# Access Compliance Report

## Public Rights-of-Way

Intersection ID: 31724	Main Street: FILBERT_LN	Cross Street: PAPER_BIRCH_DR	Location: SW
ADA ID: C838A5766229	Ramp Type: PerpDiag	Initial Pass/Fail: Fail	Overall Compliance: No
		Severity Score: 8.75

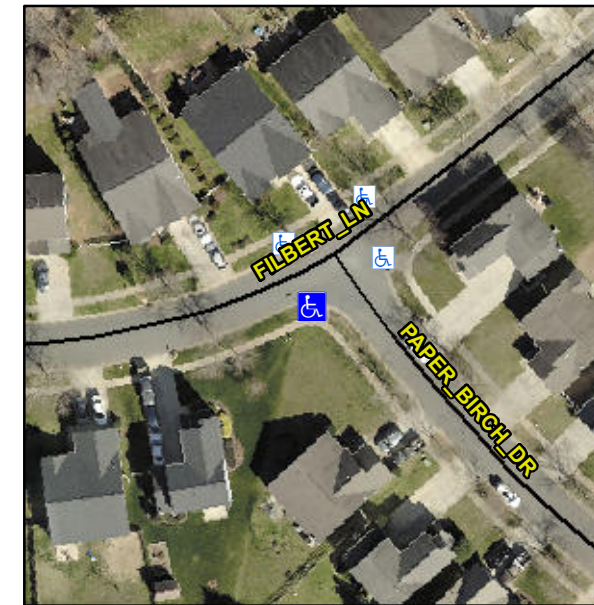
**Not Found, R304.5.1**

Compliance	Description	Data	Compliance	Description	Data
N/A	Ramp Length (in)	87.0	Yes	Ramp Slope (%)	5.6
No	Ramp Width (in)	37.5	Yes	Ramp XSlope (%)	0.2
N/A	Flare Type LT	N/A	N/A	Flare Type RT	N/A
N/A	Flare Slope LT (%)	N/A	N/A	Flare Slope RT (%)	N/A
N/A	Flare Traversable LT?	N/A	N/A	Flare Traversable RT?	N/A
N/A	Landing Length (in)	N/A	N/A	DWS Provided?	N/A
N/A	Landing Width (in)	N/A	N/A	DWS Contrast?	N/A
N/A	Landing Slope (%)	N/A	N/A	DWS Length (in)	N/A
N/A	Landing X Slope (%)	N/A	N/A	DWS Full Width?	N/A
N/A	Landing Curb? (Y/N)	N/A	N/A	DWS Offset (in)	N/A
N/A	Shared Landing?	N/A			
N/A	Gutter Ponding?	N/A	N/A	Gutter Slope (%)	N/A
N/A	Gutter Lip Ht (in)	N/A	N/A	Gutter X Slope (%)	N/A
N/A	Painted X Walk1?	No	N/A	Painted X Walk2?	No
	X Walk 1 Direction	To NE		X Walk 2 Direction	To NW
N/A	X Walk 1 Width (in)	N/A	N/A	X Walk 2 Width (in)	N/A
	X Walk 1 Slope (%)	3.7		X Walk 2 Slope (%)	1.3
	X Walk 1 X Slope (%)	0.2		X Walk 2 X Slope (%)	2.0

**Remove & Replace Curb Ramp With Two New Directional Ramps or Equivalent.**
